VIRGINIA ELECTRIC AND POWER COMPANY RICHMOND, VIRGINIA 23261

VIRGINIA ELECTRIC AND POWER COMPANY (DOMINION) NORTH ANNA POWER STATION UNITS 1 AND 2 PROPOSED IMPROVED TECHNICAL SPECIFICATIONS REQUEST FOR ADDITIONAL INFORMATION (RAI) SECTION 3.7, "PLANT SYSTEMS" (TAC Nos. MB 0799 and MB 0800)

Proposed Improved Technical Specifications Responses to Requests for Additional Information ITS 3.7, "Plant Systems"

RAI 3.7.3-1

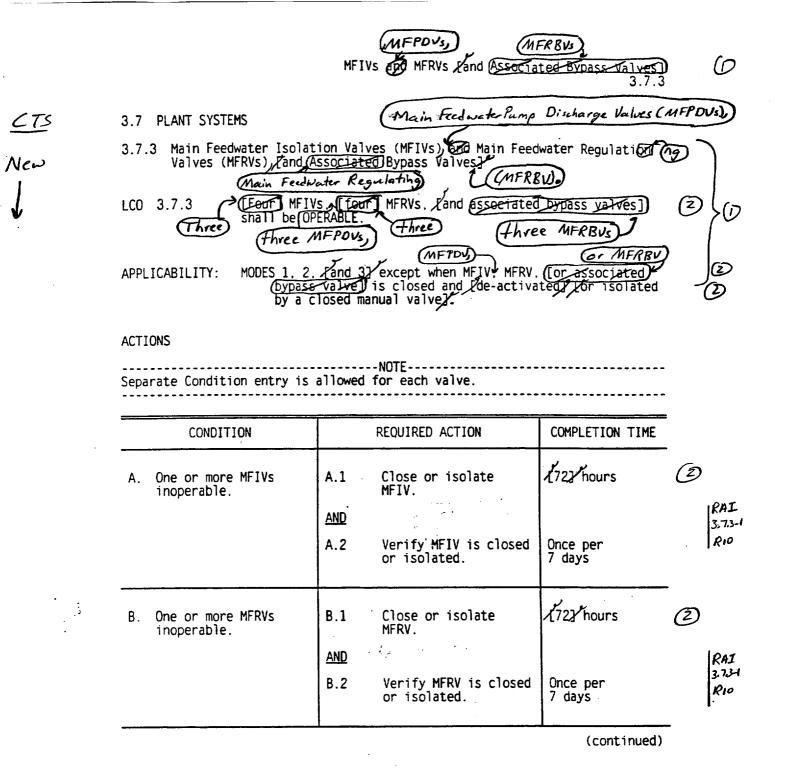
NRC RAI: Allowing verification that specified inoperable feedwater valves are closed once per 7 days "by administrative means" in ITS 3.7.3 ACTIONS is a general proposal that is being reviewed by the NRC's staff. The reason for this deviation from the STS is that there is no control room valve position indication of the feedwater valves. **Comment:** Explain why local direct valve position verification is not possible, such that administrative controls must be relied upon. Then describe the administrative controls that would be employed. Also, the Bases say "by direct or administrative means," and this appears to conflict with the ITS action statements. This comment is associated with beyond-scope item number 14 on Attachment 4 to the submittal cover letter and is being reviewed under TACs MB1430 and MB1434.

Response: The Company agrees with the action recommended in the Comment. The changes to the Actions that added "by administrative means" are eliminated.

AFW System B 3.7.5

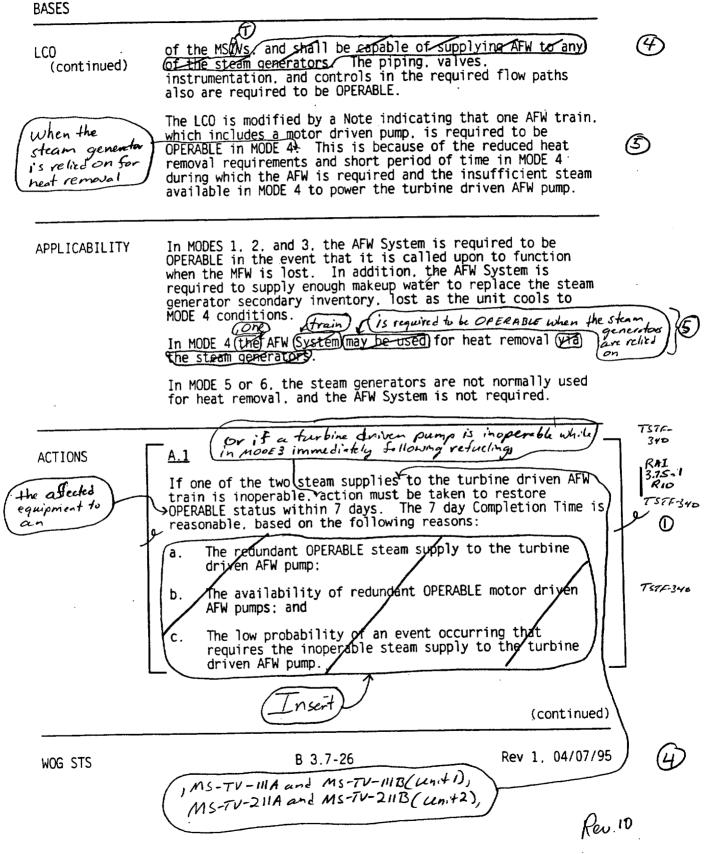
Comment: The ITS should adopt the TSTF 340 language for consistency with STS Revision 2.

Response: The Company agrees with the action recommended in the Comment. The term "affected equipment" will replace the wording "inoperable equipment" for consistency with TSTF-340, Revision 3.
